## 2.1.4 AMENDMENT 4: CPW

### Extension of CPW level 09 roof parapet over CPH main roof

APPROVED ELEVATION  
Drawing: 19559-CPA West Elevation

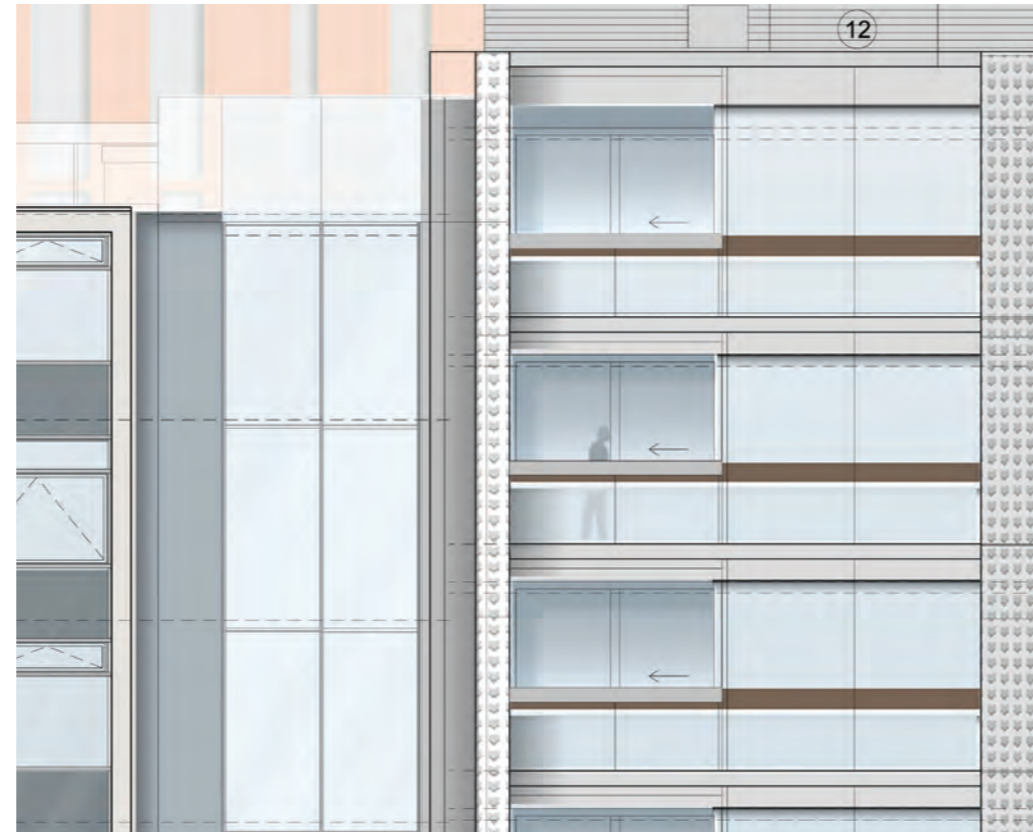
As a result of the Party Wall vent shaft and a complex set of structural conditions, including the interface between existing steel and proposed concrete structures and various movement joint and deflection issues, it is necessary to extend the CPW roof slab by an average of 200mm northwards over the existing CPH roof. This ensures a suitably robust and weather tight detail to be achieved at the head of the Party Wall.

This amendment will have little visible effect on the elevation, as it lies behind the rooftop balustrade to CPH.
